AMENDMENTS TO THE DRAWINGS

FIGS. 8A through 8J are schematic cross-sectional views illustrating a twin-ONO-type SONOS memory according to a fourth embodiment of the present invention;

APPENDIX B - ANNOTATED DRAWING reflecting proposed changes to original Figs. 8I and 8J, shown in red.

FIG. 8I

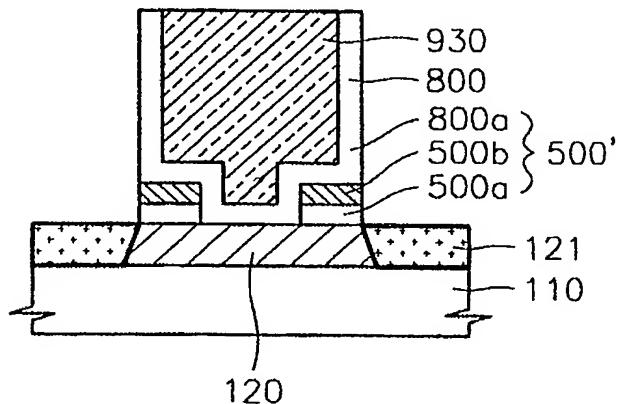
A proposed amendment to Figs. 8I and 8J is presented in the annotated drawing which appears, as APPENDIX B, on page 6. Specifically, the conductive layer 930 of Figs. 8I and 8J has been changed from a double layer to a single layer. The change is proposed to correct an obvious error as is apparent from preceding Fig. 8H and the drawing descriptions in the specification.

Attached hereto, as APPENDIX C, on page 7, is a replacement sheet of formal drawing depicting Figs. 8H, 8I and 8J, which incorporates the proposed amendment to Figs. 8I and 8J.
